Response to comments from Erik Kiviatt dated January 20, 2017

Response to comments from Andrew Willingham dated January 24, 2017

SITE PLANS FOR YUKIGUNI MATTAKE MANUFACTURING CORPORATION OF AMERICA TOWN OF MAMAKATING, SULLIVAN COUNTY, NEW YORK

JUNE 25, 2008
REVISED DECEMBER 22, 2010
AMENDED DECEMBER 2, 2016
REVISED JANUARY 9, 2017
REVISED FEBRUARY 3, 2017

McDonald Road Improvements

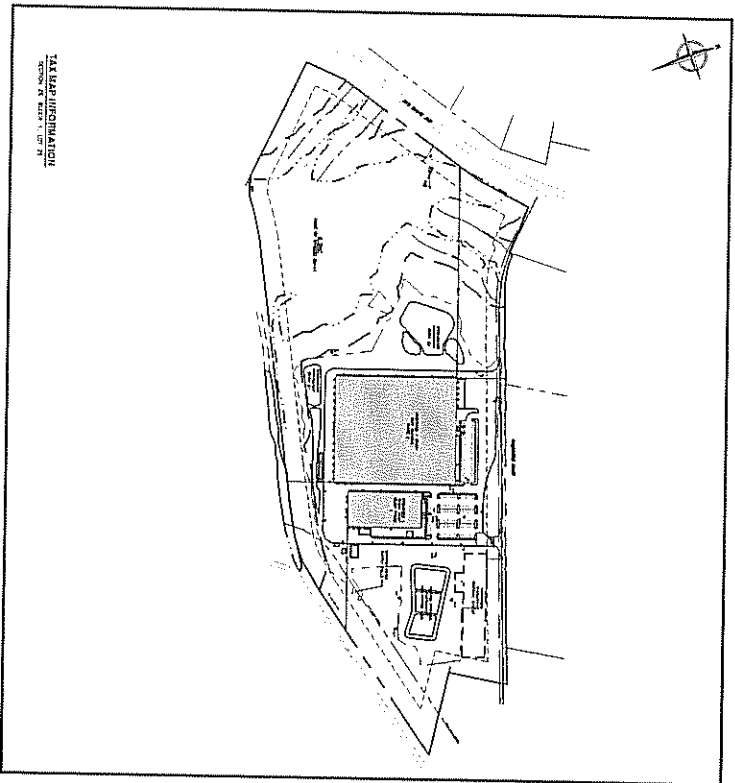
Required improvements to MacDonald Road were discussed in YM's SEQR Findings Statement, earlier Site Plan Resolutions and my previous letter to the Board dated 08/27/08. MacDonald Road is in poor condition and incapable of managing the additional traffic generated by the BE project. Despite the above, no road improvement plans or schedule have been supplied for MacDonald Road. Sheet 5 of the Site Plan contains a vague description of the required improvements with no phasing schedule, plans or construction details. A note on Sheet 6 indicates "Detailed grading associated with road widening not shown. This information shall be shown on road widening construction plan and shall be reviewed and approved by the Town Engineer and Town Highway Supervisor." To prevent segmentation and allow full review of the proposed improvements by the Board, public and other agencies, the Road Widening Construction Plan should be included in the BE Site Plan Set. The phasing of the improvements is also not clear. The required improvements to MacDonald Road are significant and should not be described with a few notes on the plan.

Please see the response to Mr. Paggi's comment No. 1 regarding the planned road improvements.

SHEET NO. 4

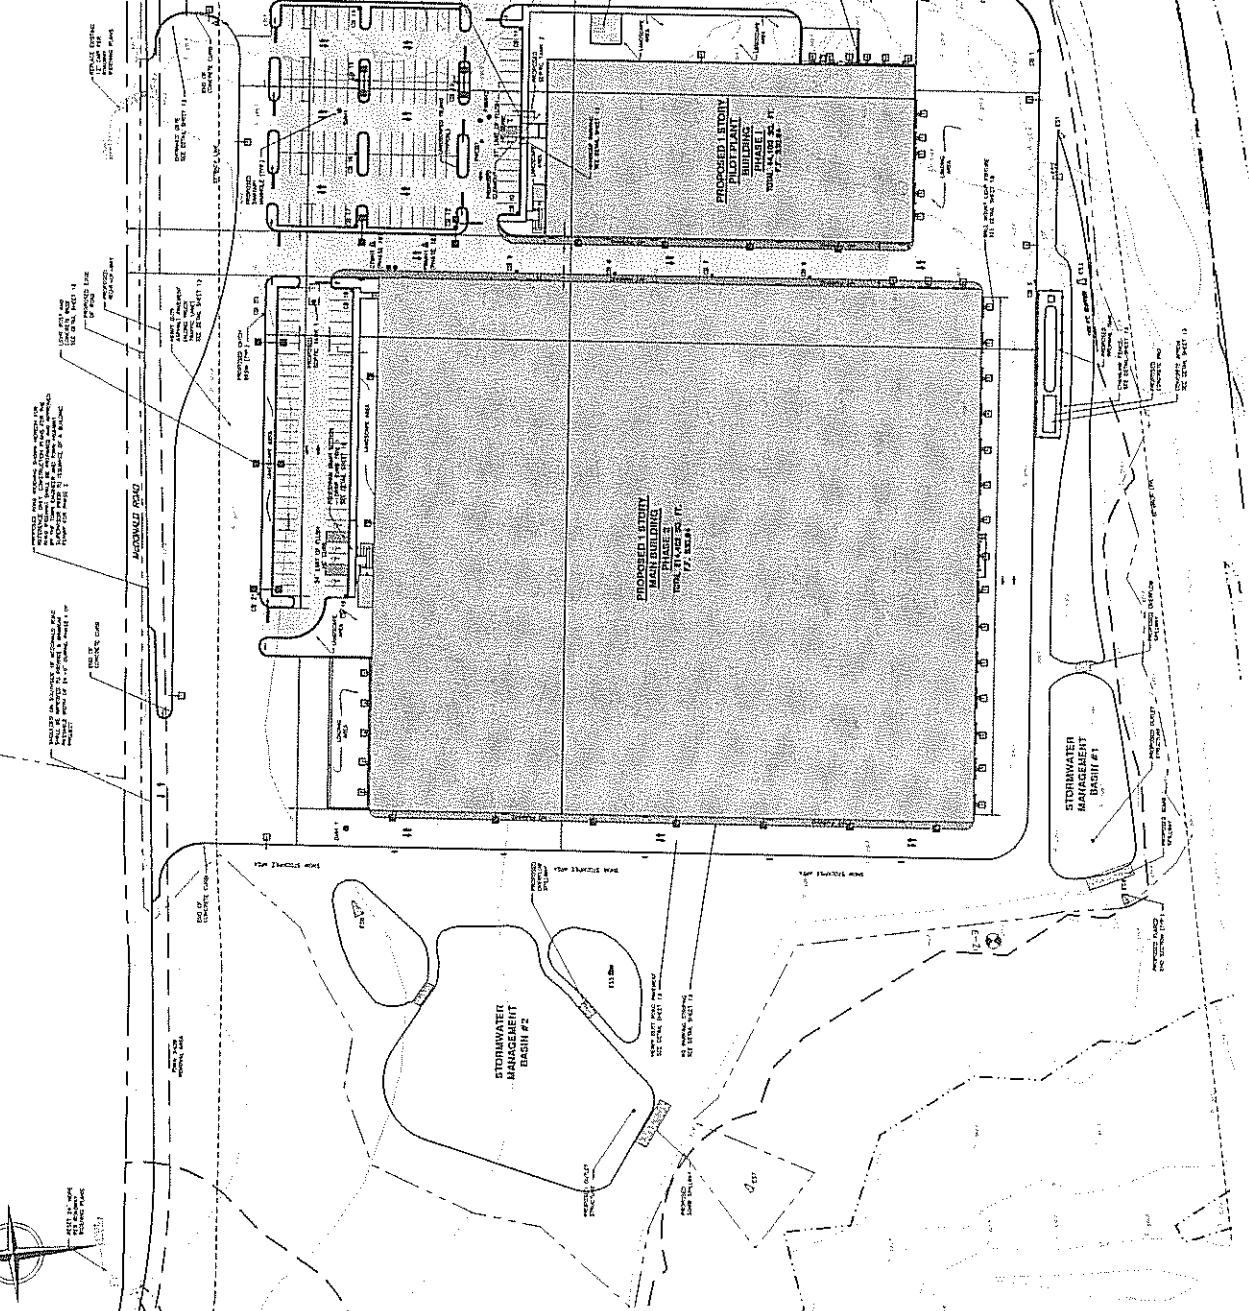
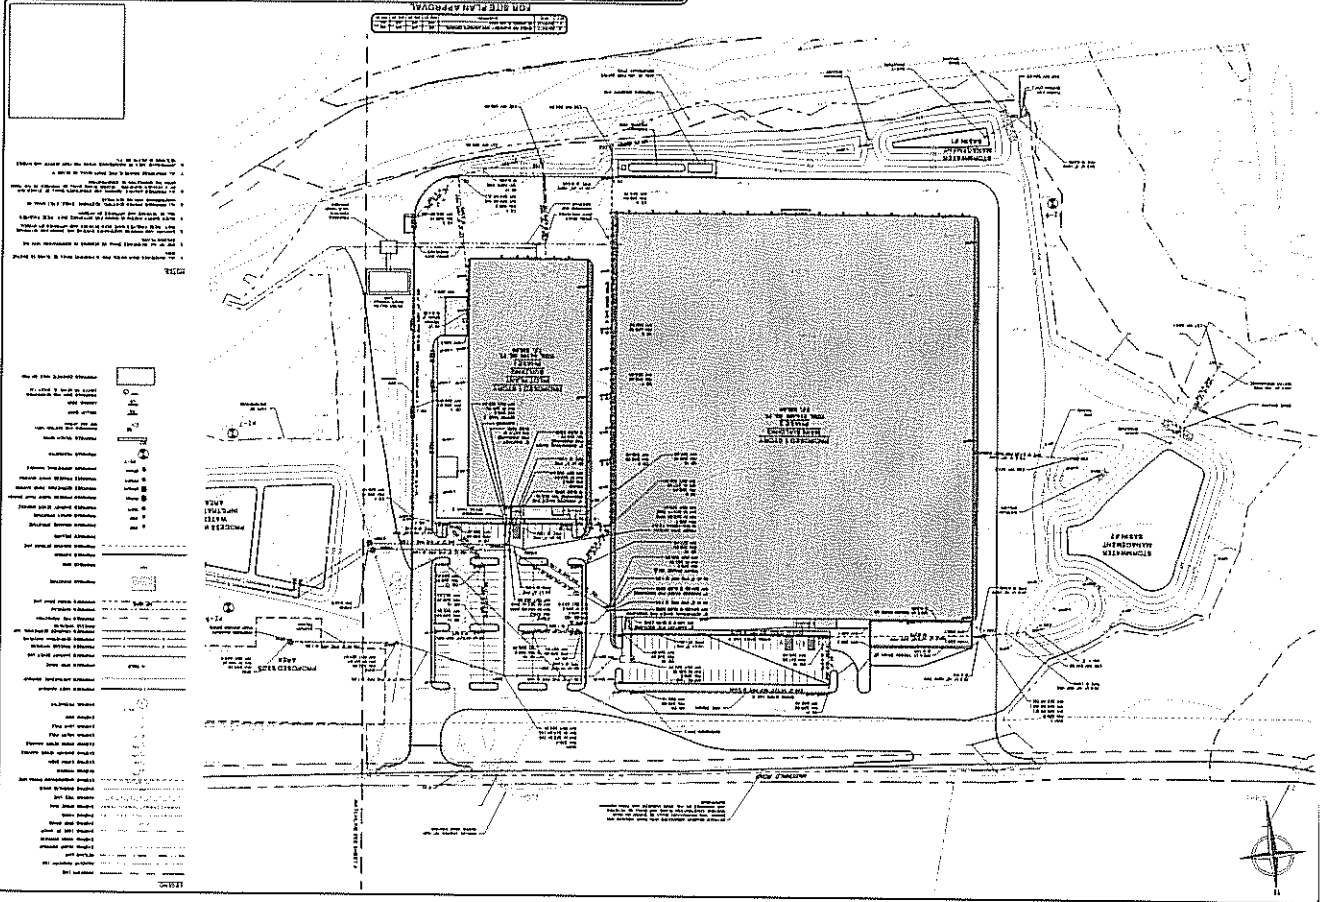
Note 9 says that there are no changes to this sheet. There are no changes to the footprint but there are changes to the notes on the map.

There were no revisions to the notes on Sheet 4, however they will be modified to indicate works in either Phase 1A or 1B.
